Document No.: RN-240614-01
Date: June 14, 2024
Classification: External
Priority: Routine
Attn: All Customers
Related Products: FB250, Fleet One
Subject: **FB250, Fleet One Firmware Release Note – V2.0.1**

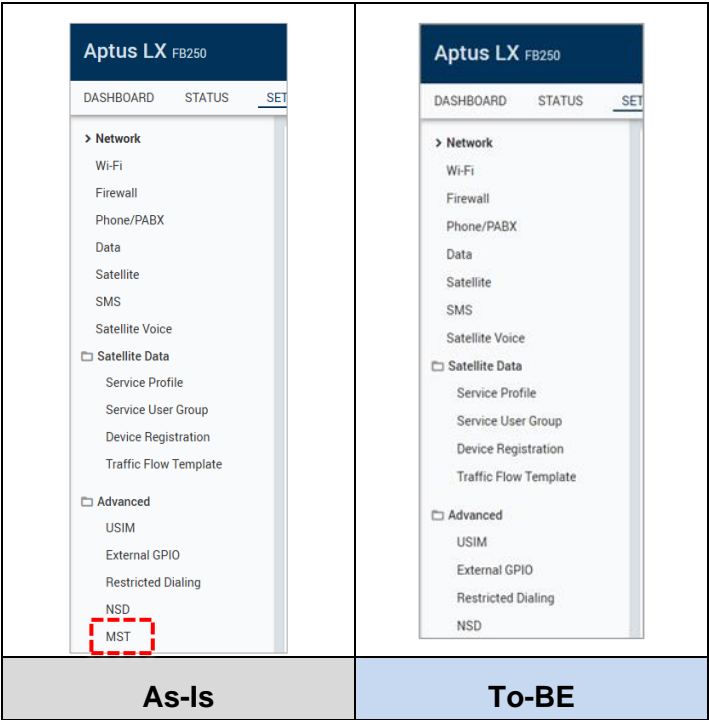
- 1.1. MST related items are deleted in Aptus LX. Marine Safety Terminal (MST) functionality was implemented to support implementation of now discontinued GMDSS service.

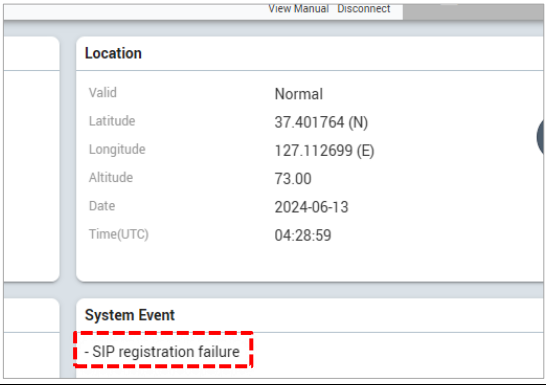
- 2.1. Update to requirements linked to a customer (CTTIC).

- Diagnostics test mode is now displayed in Operation mode. When diagnostics test mode is deactivated, SIP Registration failure will not be displayed once it is connected to the SIP Server within 5 minutes.
- Change to prevent SIP Registration failure when terminal first turned ON. Modified to forcefully send a “SIP Registration” message once every 5 minutes and if cannot be connected for over 5 minutes, the SIP Registration failure message will be displayed.
